To: Gus Finlayson – Barker & Associates

From: Terra Studio

Re: Memorandum in Response to Auckland Council Parks Delmore Request for Further Information

Figure 3 - Rendered Cross Section of the Stage 1 Neighbourhood Park. Approximately Half of the Park is Shown

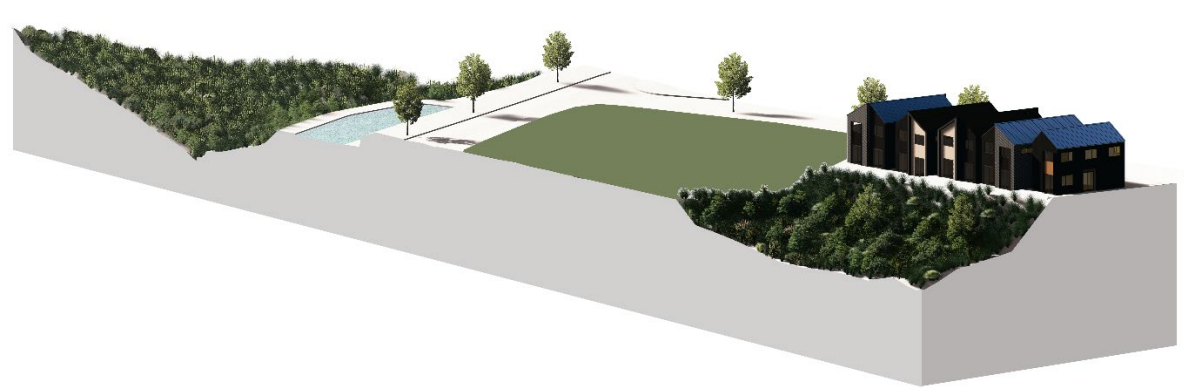
4.4 d,e	<p>In response to Mr. Cas Hannink's Auckland Council Parks memo dated 25/06/2025, the applicant has increased the proposed Stage 1 park area to approximately 3,100m². Earthworks have been refined to provide a flat 30m x 30m kickball area, with surrounding gradients not exceeding 5% (1:20). No retaining structures are proposed within the park, although a retaining wall under 1.5m with a permeable fence is proposed within Lot 358 along the park's northern boundary. A 1:1 slope is located outside the park boundary, sloping toward the eastern wetland. Refer to the submitted Terra Studio document "250702 – DELMORE – RFI RESPONSE – PARKS" for further details.</p> <p>As such, this park meets all key metrics and should trigger acquisition by Auckland Council.</p>

6.4	<p>The Stage 1 park has been refined to meet all key metrics. These include:</p> <ul style="list-style-type: none">Increased to have an overall area of 3,100m².30x30m unobstructed kick ball space at gradients no greater than 3%.Land gradients no greater than 5% outside the kickball area.Freedom from infrastructure – a retaining wall that is smaller than 1.5m at lot 358 to the north, and a 1:1 slope towards the existing stream to the west outside of the park boundary. <p>Refer to the response to Item 4.4b for details regarding the proposed Stage 2 park, which meets all key metrics with the exception of maximum gradients outside of the ‘kick-ball’ area</p>
6.5	<p>The Stage 1 park has been increased to 3,100m², meeting this key metric and making it a neighborhood park rather than a pocket park.</p>
